Access Compliance Report

Public Rights-of-Way

(Curb Ramps)

Intersection ID: 13561	Main Street: BAY_ST	Cross Street: LAMAR_AV	Location:	N
ADA ID: 28E65FCB83B9	Ramp Type: PerpDiag	Initial Pass/Fail: Pass	Overall Compliance: No	Severity Score: 0
Codes/Mitigation Info/Possible Solution		Field Measurements/Component Compliance

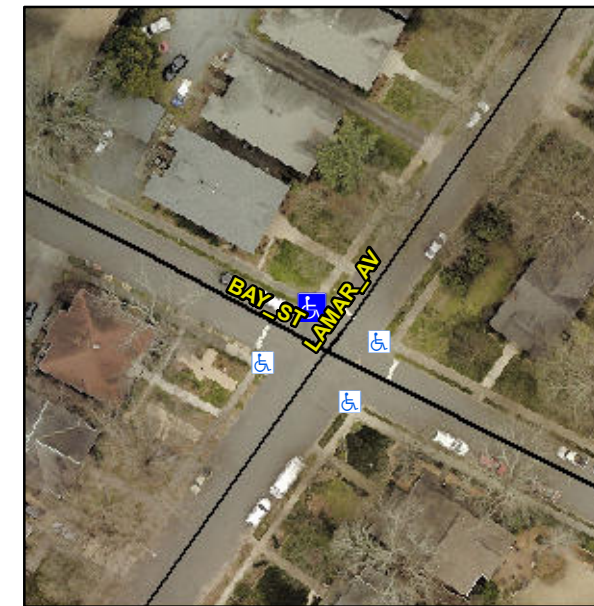
R304.2.1, R304.2.2-Perp, R304.3.2-Para, R305.2

Compliance	Description	Data	Compliance	Description	Data
N/A	Ramp Length (in)	64.0	Yes	Ramp Slope (%)	7.3
Yes	Ramp Width (in)	84.0	Yes	Ramp XSlope (%)	1.6
N/A	Flare Type LT	Sloped	N/A	Flare Type RT	N/A
N/A	Flare Slope LT (%)	5.7	N/A	Flare Slope RT (%)	9.3
N/A	Flare Traversable LT?	Yes	N/A	Flare Traversable RT?	No
No	Landing Length (in)	36.0	Yes	DWS Provided?	Yes
Yes	Landing Width (in)	48.0	Yes	DWS Contrast?	Yes
No	Landing Slope (%)	2.2	Yes	DWS Length (in)	24.0
Yes	Landing X Slope (%)	1.1	Yes	DWS Full Width?	Yes
N/A	Landing Curb? (Y/N)	No	No	DWS Offset (in)	9.0
N/A	Shared Landing?	No			
Yes	Gutter Ponding?	No	Yes	Gutter Slope (%)	0.0
Yes	Gutter Lip Ht (in)	0.0	Yes	Gutter X Slope (%)	0.4
N/A	Painted X Walk1?	No	N/A	Painted X Walk2?	No
	X Walk 1 Direction	To SW		X Walk 2 Direction	To SE
N/A	X Walk 1 Width (in)	N/A	N/A	X Walk 2 Width (in)	N/A
	X Walk 1 Slope (%)	3.4		X Walk 2 Slope (%)	4.5
	X Walk 1 X Slope (%)	4.6		X Walk 2 X Slope (%)	4.9

N/A	Ramp inside XWalk1?	N/A	N/A	Ramp inside XWalk2?	N/A
	Road Slope (%)	3.2	N/A	Clear Space?	Yes
	Road X Slope (%)	7.9	N/A	Clear Space to XWalk (in)	N/A
Yes	Any Obstructions?	No	Yes	Storm Grate/Utility Hazard?	No
	Obstruction Type			Storm Grate/Utility Type	
		N/A			N/A
			Yes	Surface Condition? (G/P)	Good

Remove & Replace Curb Ramp With Two New Directional Ramps or Equivalent.
